# **COUNCIL'S FURTHER REVIEW OF BUSHFIRE IMPACT**

## **PLANNING PROPOSAL TO REZONE LAND AT 95 – 97 STANHOPE ROAD, KILLARA**

### **Ku-ring-gai Council August 2018**

**Figure 3 -**  
95 Stanhope rd, Killara Bushfire Prone Land Connectivity

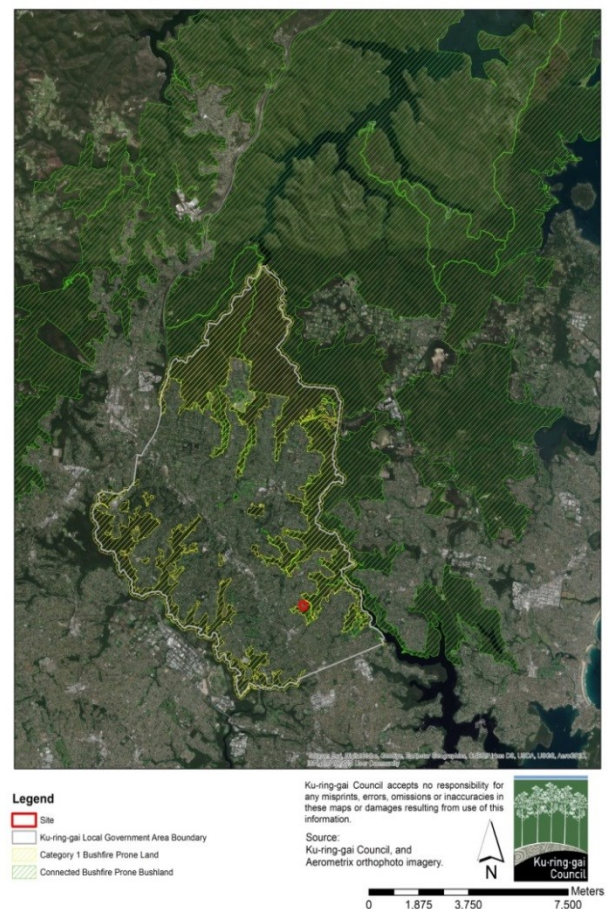
Council (as supported by their independent bushfire consultant), maintain that the site is subject to significant exposure to bushfire attack from the south, east and also from the **north east**.

The site adjoins more than 38,500 ha of bushfire prone bushland, contains areas of steep terrain and ***"is exposed to a 1.2 Kilometre fire path from the northeast with a potential head width of more than 300 metres. The fire***

path from the southeast has a length of more than 450 metres with a potential head width of more than 250 metres” (pg.9 -10, Australian Bushfire Protection Planners April 2018), as outlined within figure 2 and 3 (below).
